170 Rhodes Avenue,
Akron, Ohio.
January 23, 1940.

170 Rhodes Ave.,
Akron, Ohio.
July 22, 1940.

Spillway dam section.

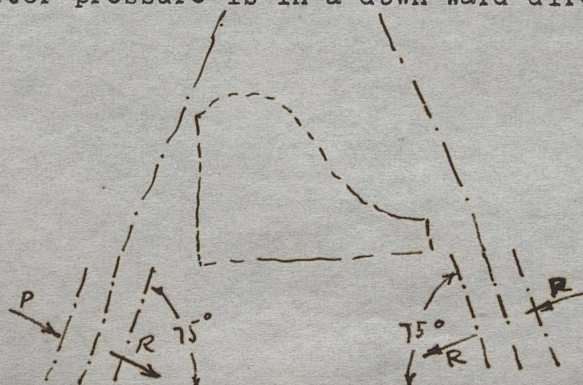
One of the progress reports states that you have had to carry the rock excavation in the vicinity of the dam two feet or more and may possibly go deeper. The section as shown on the drawings for Crest El. 85 and 87 was designed on the following assumptions.

- a) Rock at el. 69 (max. height 16' and 18' respectively)
- b) H.W. el. 99.0 (max. overflow 14' and 12' do)
- c) Net section exclusive of bucket.
- d) Uplift as per diagram below.

Note that results are in pressures over entire base rather than percent of base subjected to full pressures.

It can be seen from the above that if the excavation is carried any appreciable depth below the design elevation without due compensation for same, the stability of the structure is effected and the factor of safety is lowered. The only method of compensating for the removal of rock below el. 69, in my estimation, is as follows. Excavation to be confined to limits two feet up and down stream from the limits of the pad base shown for elevation 69. Vertical faces of excavation to be maintained as such. Grouting the area immediately up and down stream after pouring the concrete to bring the excavated portion up to el. 69. Grouting to extend a distance from the edge of the excavation equal to threetimes the depth of the excavation and to penetrate a distance equal to twice the depth of the excavation. These distances are a minimum and of course are to be governed by the field conditions. The pressure of the grout should not exceed one and one half pounds per foot of depth of grout hole. Briefly summed up, the rock foundation should be possible of excellent consolidation or the section should be revised to cover the altered condition, if it is desired to maintain the same factor of safety.
